Objection to DA 2023/1469

Alterations and Additions to a Dwelling House at 955 Barrenjoey Road, Palm Beach

7. PDCP D12.8 – Building Envelope

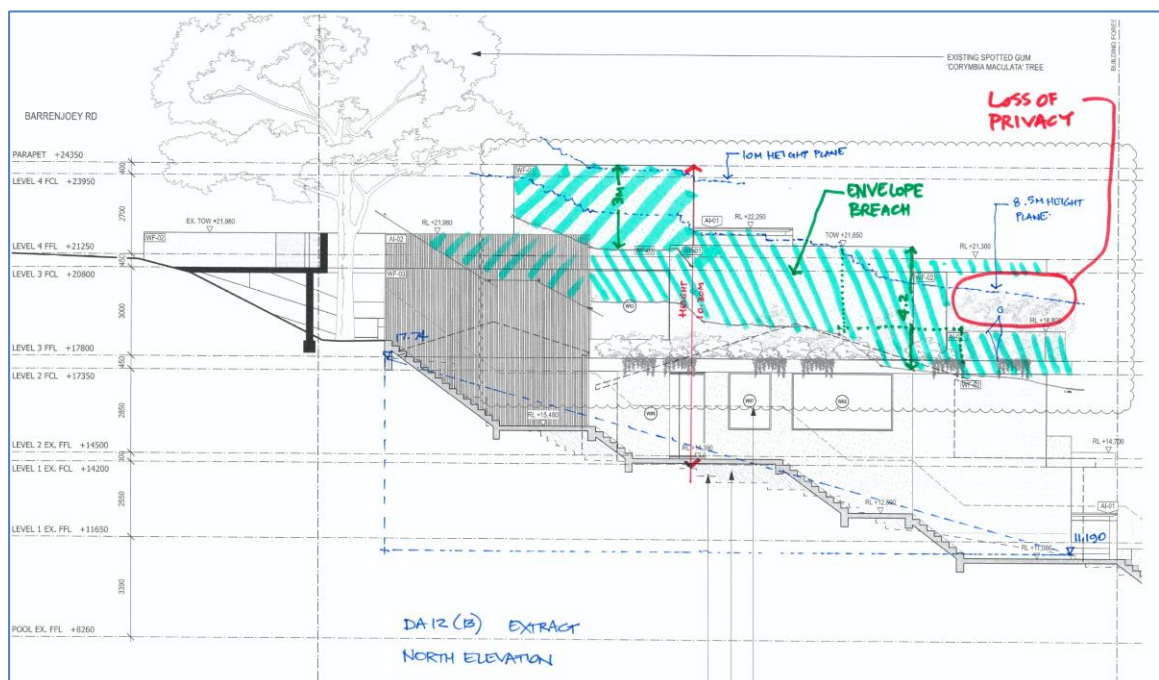
The proposal exceeds the built form control of building envelope by a full storey along the entire northern façade facing 959 as shown in the image below.

The impact of this breach is a loss of amenity on several aspects including privacy, bulk and scale and view loss. The outcomes of the policy require that bulk and scale is minimised, equitable preservation of views is maintained, and a reasonable level of privacy is provided to neighbouring properties. The proposal fails all of these.

The impacts are created because the proposal seeks to extend the rear building line past that of 959 and therefore looks back into 959 and presents an unacceptable bulk and scale as viewed from 959 from its principle living and private open spaces.

The breach of building envelope is severe, and the application should be refused on that basis.
